SIZEMORE RESIDENCE
NEW CONSTRUCTION

574 NORTON ST
LONGBOAT KEY, FLORIDA

PROJECT: SIZEMORE RESIDENCE
574 NORTON ST., LONGBOAT KEY, FL
DRAWING TITLE: COVER SHEET, COMPONENTS AND CLADDING

DETAILER: 3DR CONTACT# 786-247-2884 | DATE: 06/04/2024 | JOB NO.: 223-0663 | SHT NO.: R01

FOUNDATION PLAN

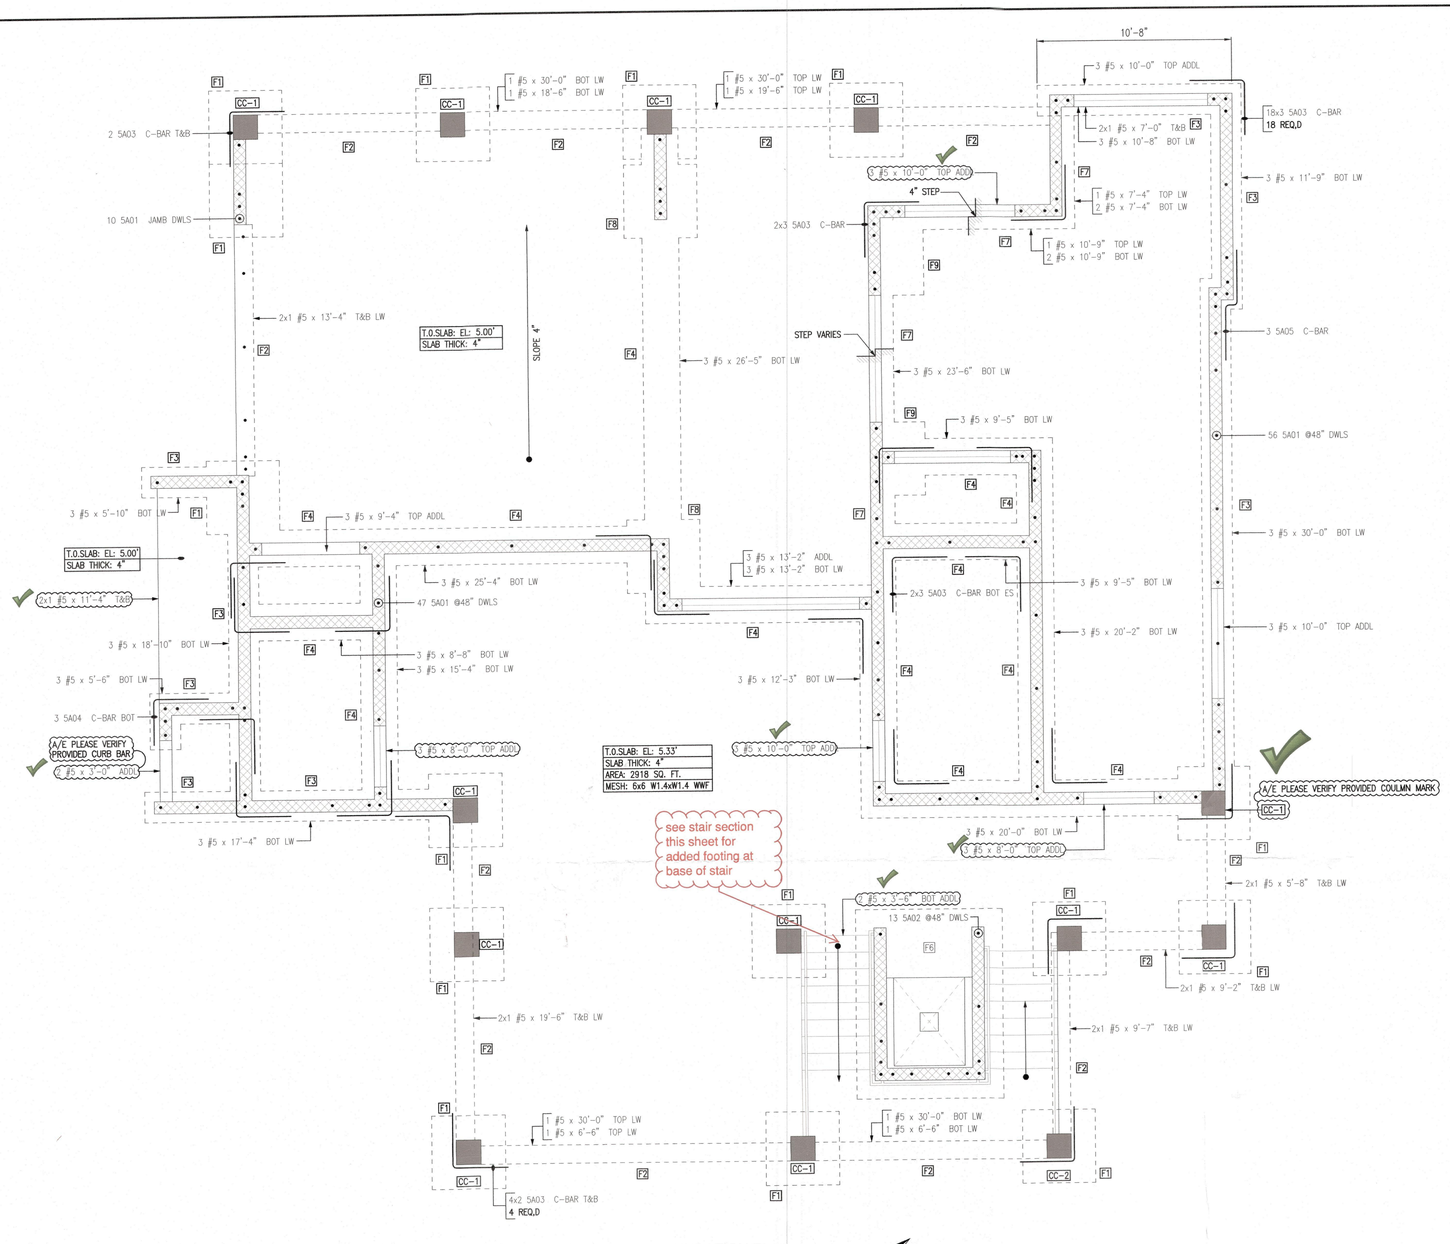
THISSHOP DRAWING IS BEING SIGNED AND SEALED BY PETER WALLIS AND ASSOCIATES AS AN INDICATION THAT WE ARE IN AGREEMENT WITH THE FOOTING ADDED AT THE BASE OF THE STAIR

RECEIVED 6/5/2024
- [ ] NO EXCEPTIONS TAKEN
- [x] MAKE CORRECTIONS NOTED
- [ ] REVISE AND RESUBMIT
- [ ] REJECTED

STAIRCASE PLAN

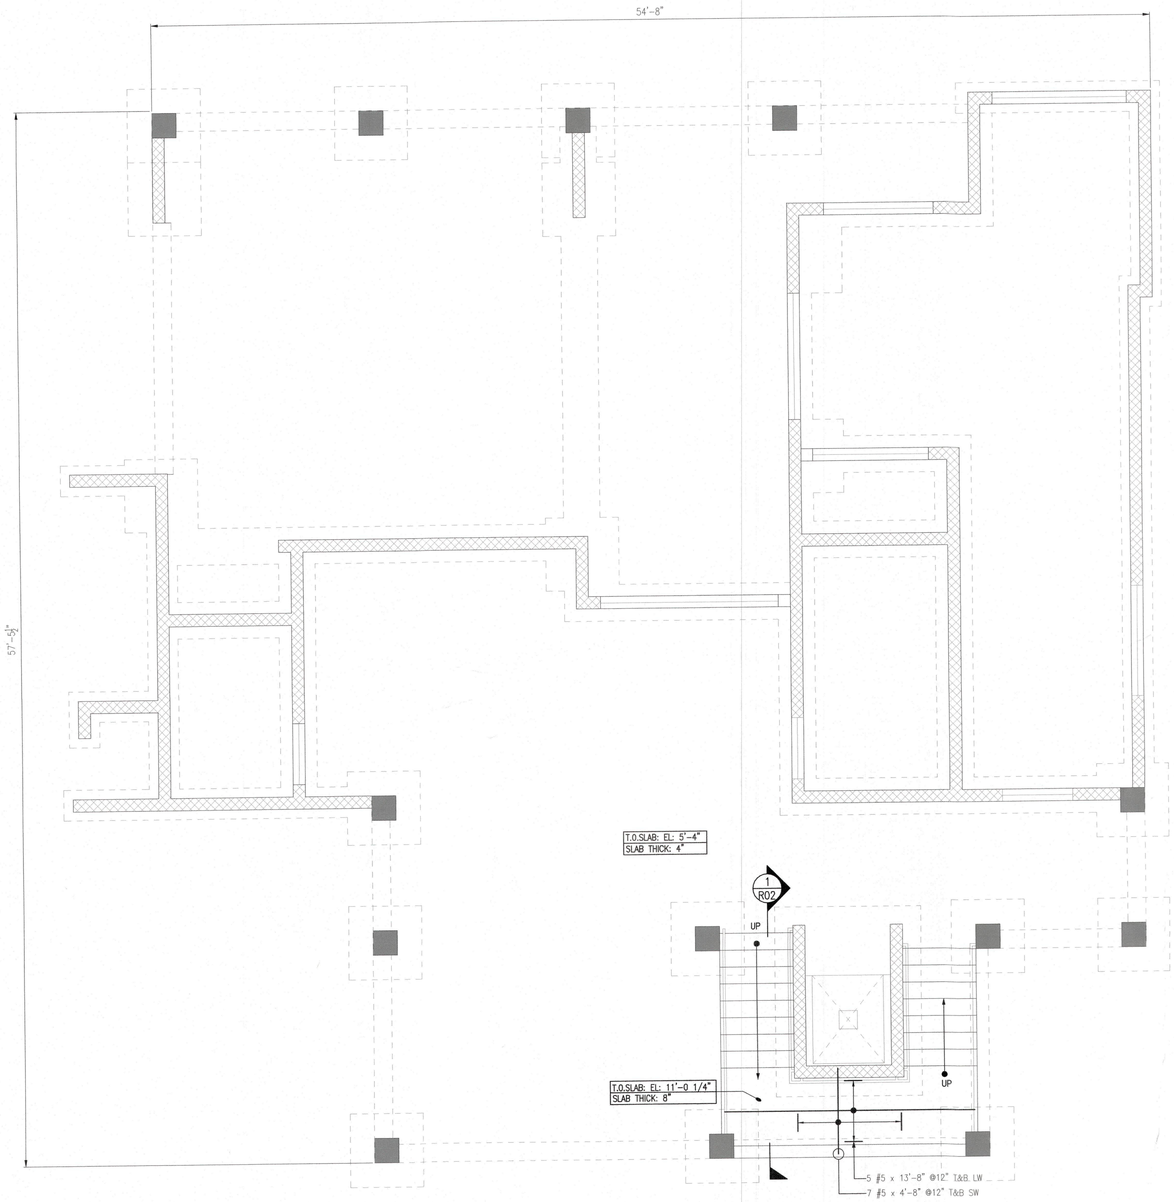
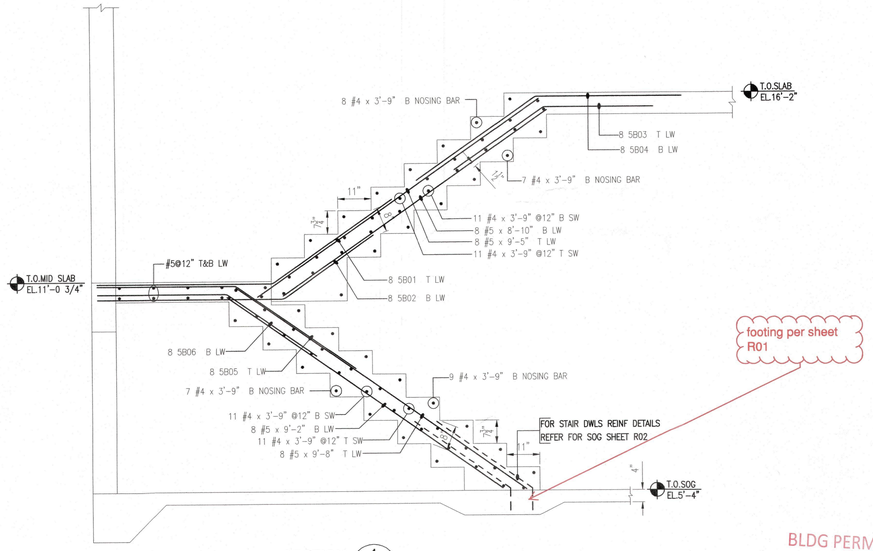
RECEIVED 6/5/2024
- [ ] NO EXCEPTIONS TAKEN
- [x] MAKE CORRECTIONS NOTED
- [ ] REVISE AND RESUBMIT
- [ ] REJECTED

FIRST FLOOR BEAM PLAN

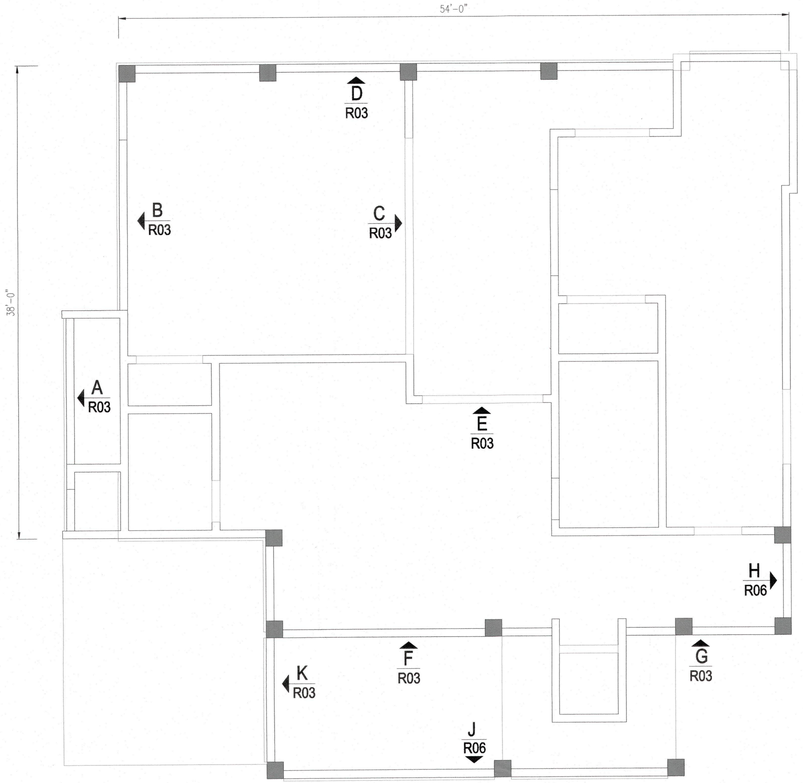
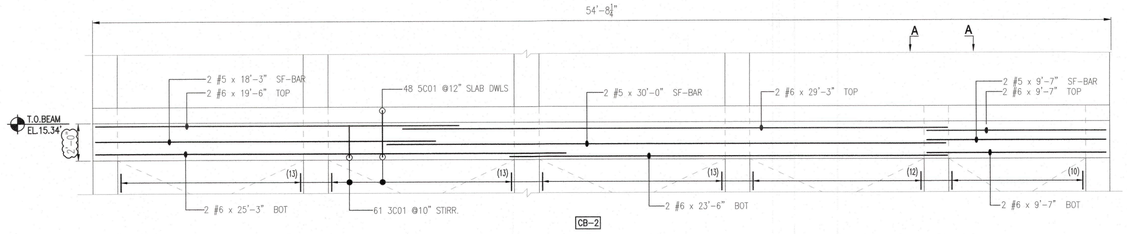
provide Z bars for top bottom and middle

RECEIVED 6/5/2024
- [ ] NO EXCEPTIONS TAKEN
- [x] MAKE CORRECTIONS NOTED
- [ ] REVISE AND RESUBMIT
- [ ] REJECTED

FIRST FLOOR SLAB BOTTOM LAYER PLAN

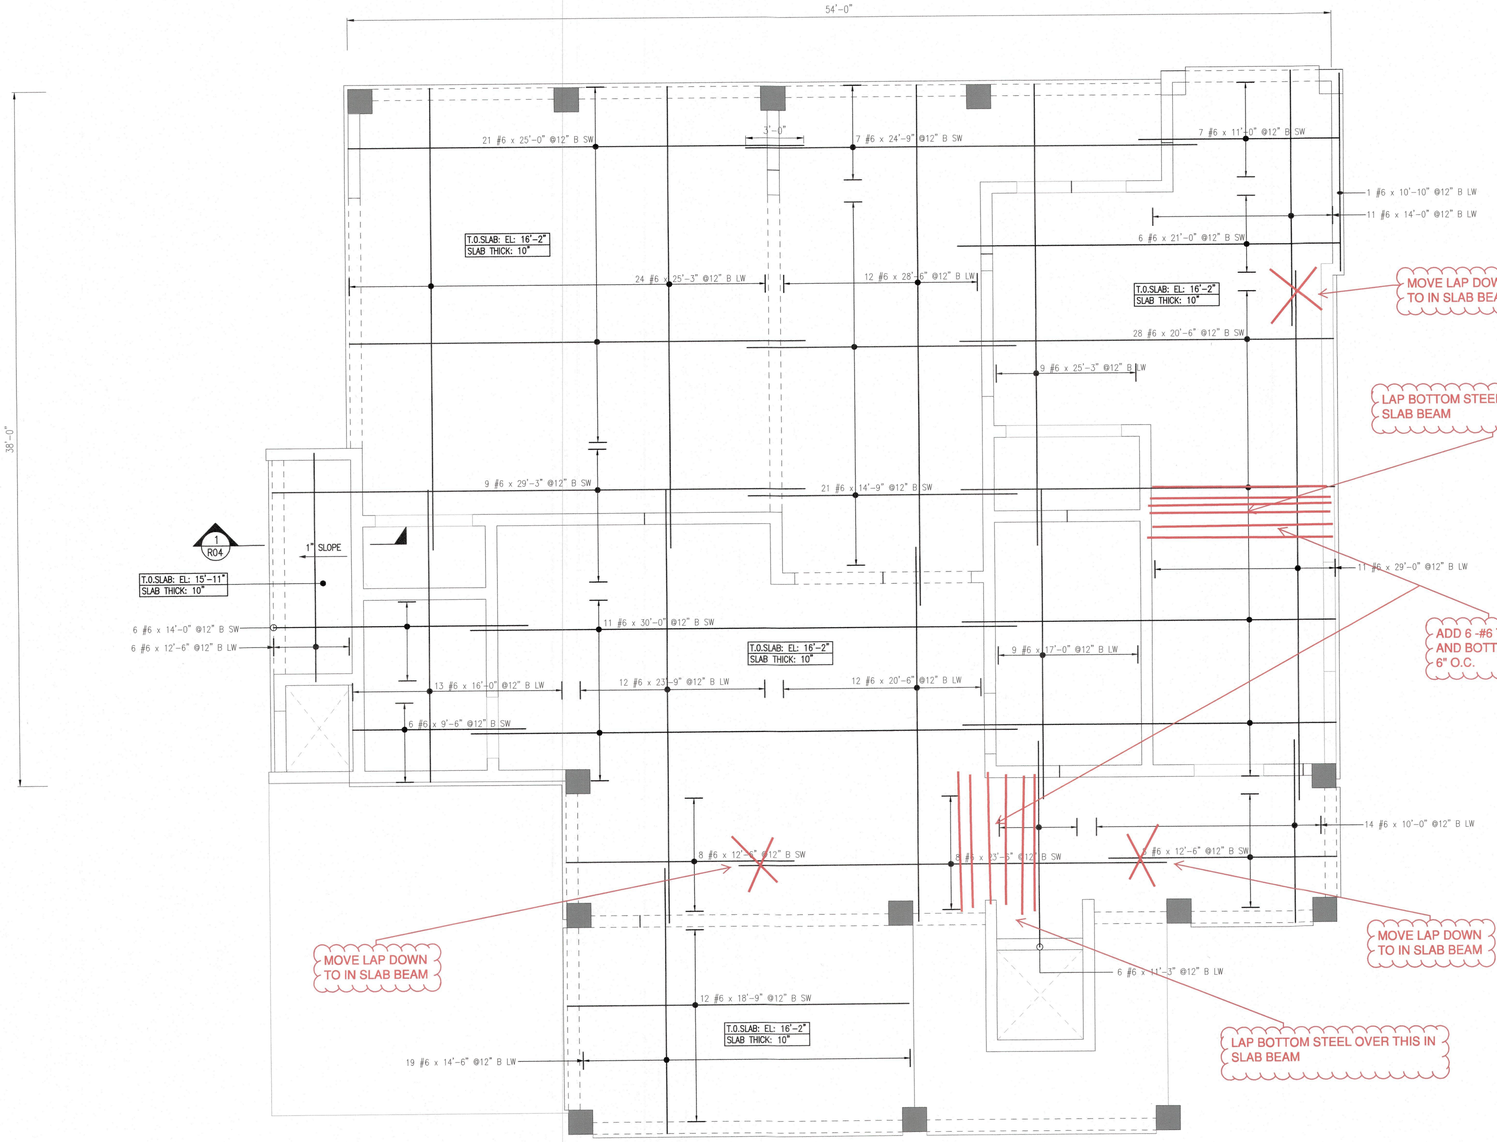
RECEIVED 6/5/2024
- [ ] NO EXCEPTIONS TAKEN
- [x] MAKE CORRECTIONS NOTED
- [ ] REVISE AND RESUBMIT
- [ ] REJECTED

FIRST FLOOR SLAB TOP LAYER PLAN

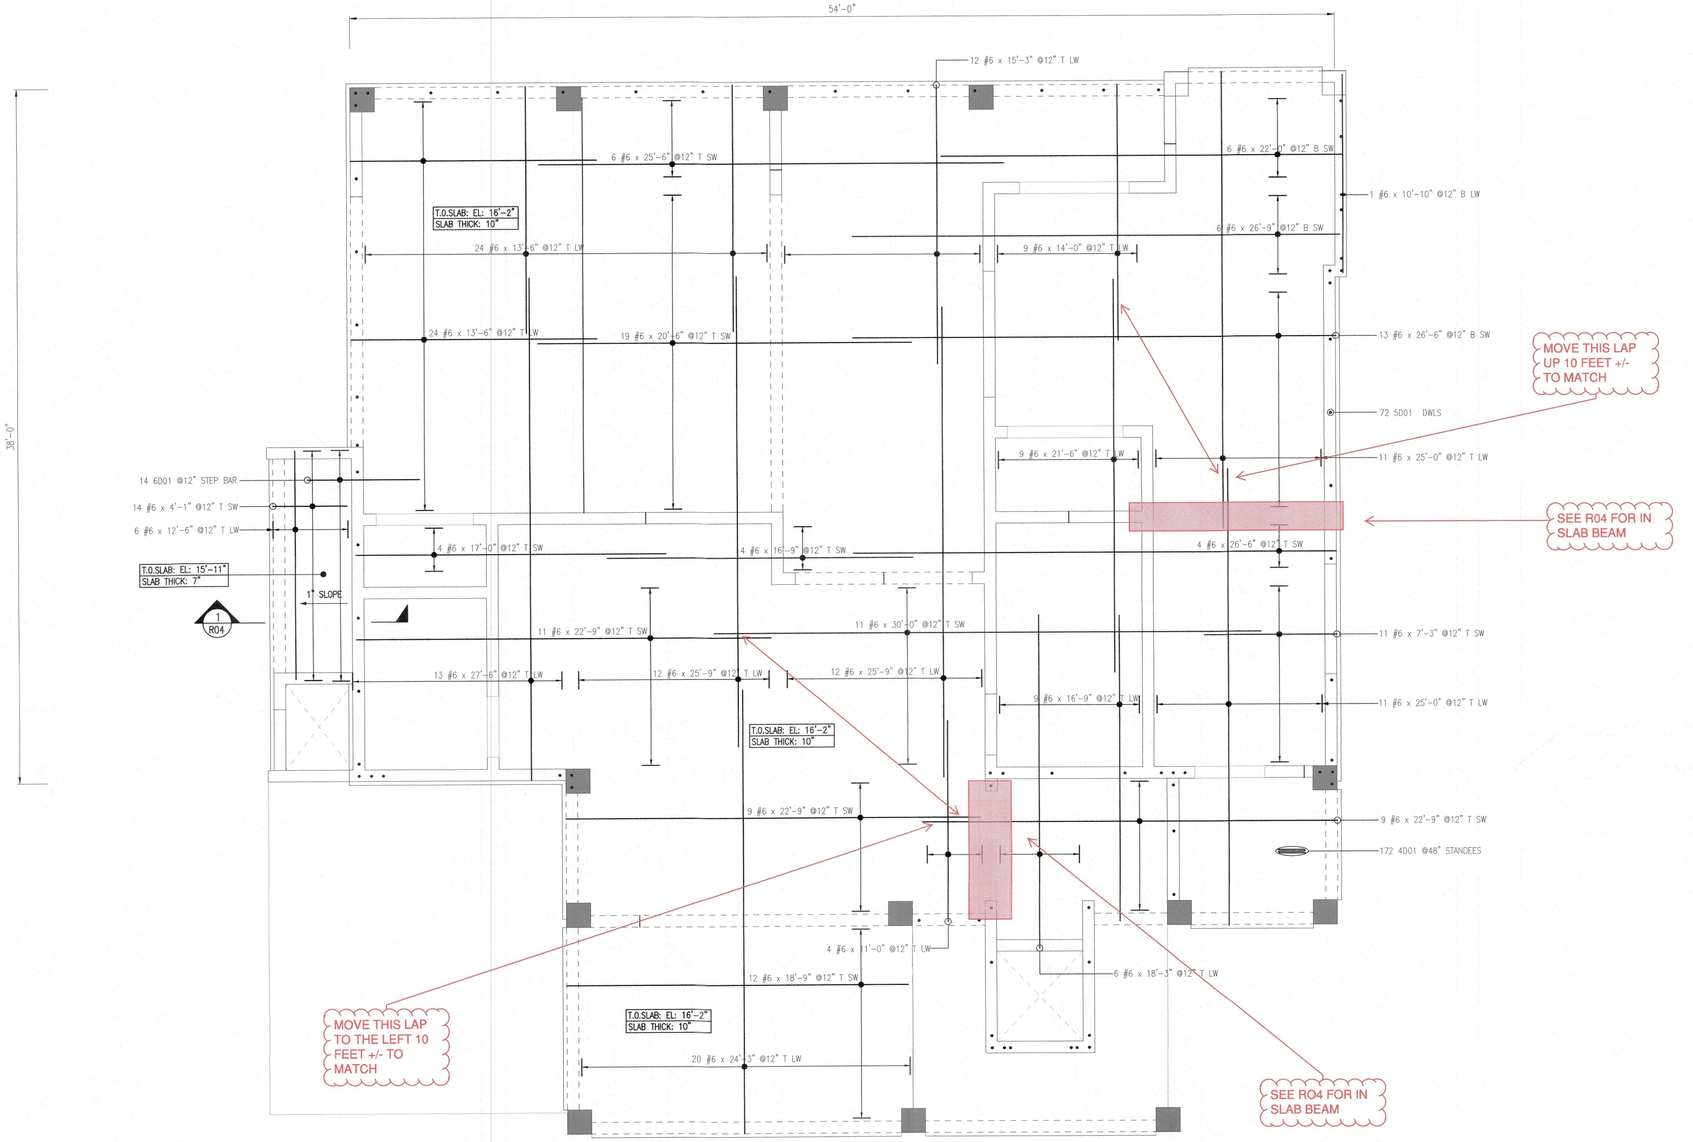
RECEIVED 6/5/2024
- ☐ NO EXCEPTIONS TAKEN
- ■ MAKE CORRECTIONS NOTED
- ☐ REVISE AND RESUBMIT
- ☐ REJECTED

ROOF BEAM PLAN

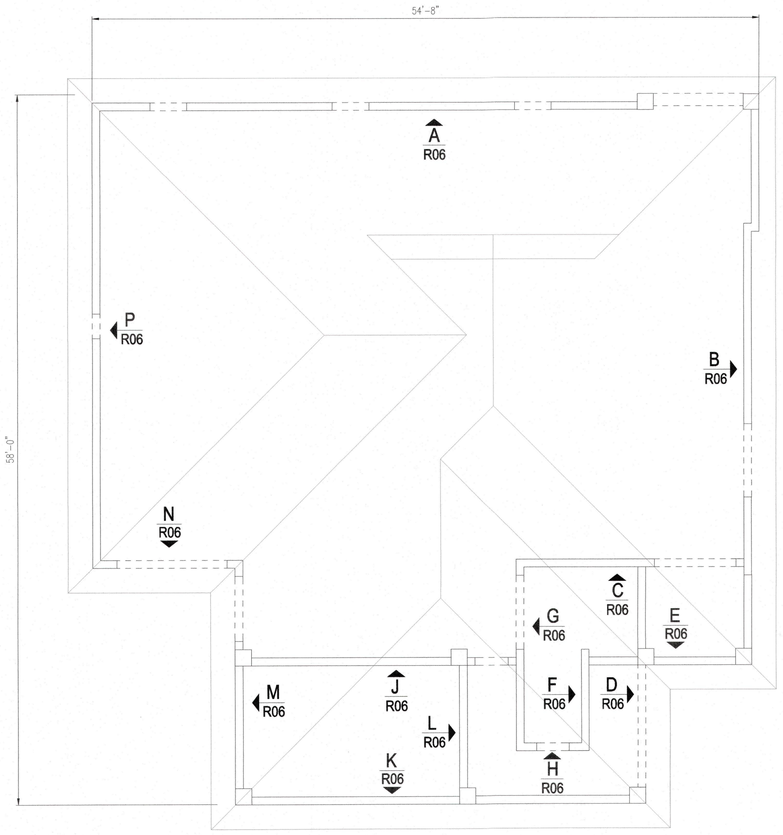
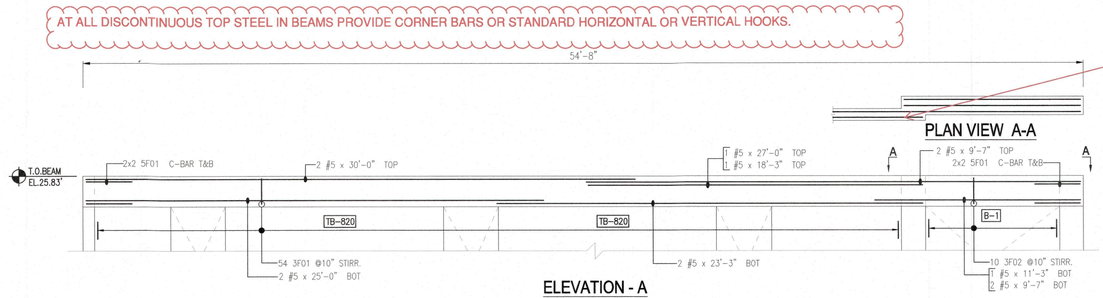
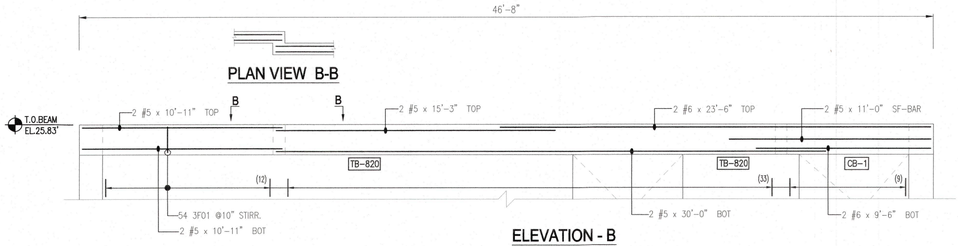
A/E PLEASE VERIFY THE LAP SCHEDULE

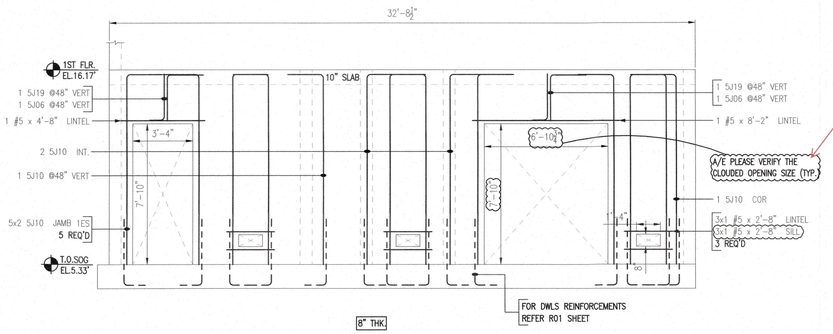
VERIFY OPENING WITH GC

A/E PLEASE VERIFY THE CLOUDED OPENING SIZE (TYP.)
